CITY OF ROCKVILLE HISTORIC DISTRICT COMMISSION
STAFF REPORT
for
June 19, 2008
MEETING NO. 06-08
[Consent Agenda]

APPLICATION: HDC2008-00436
ADDRESS: 200 W. Jefferson street
ACCEPTED: May 29, 2008
45 DAY LIMIT: July 13, 2008
OWNER: Aaron Fein
REQUEST: Replace non-original rear basement window with door.
STAFF: Cindy Kebba

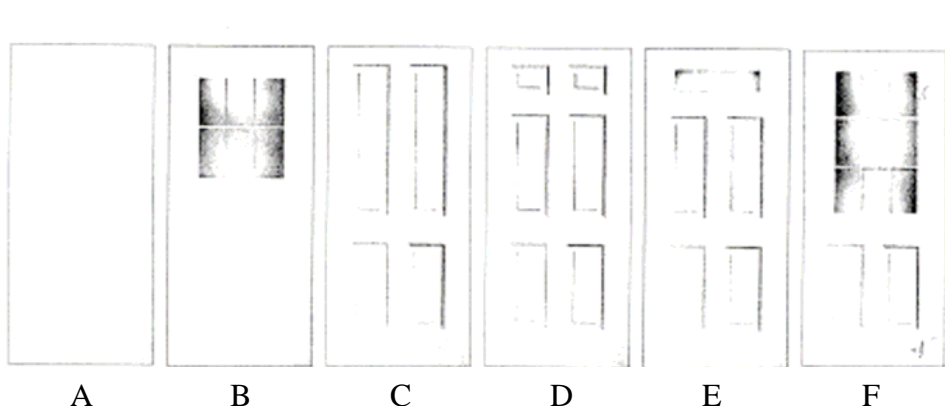
The applicant requests approval to install a metal door in place of the window in one of the following styles:

Staff recommends the plain style (A) shown at the far left because it matches that of the other basement door and would be the least detracting from the historic elements of the house. However, there are other styles of doors on the house, including paneled doors and doors with glazing in the top half. The applicant may want to allow light to enter the space and a door with top half glazing also would be compatible.

The style of the replacement door may be any of those submitted by the applicant, including plain, paneled or with glazing in the top portion as illustrated on page 4.
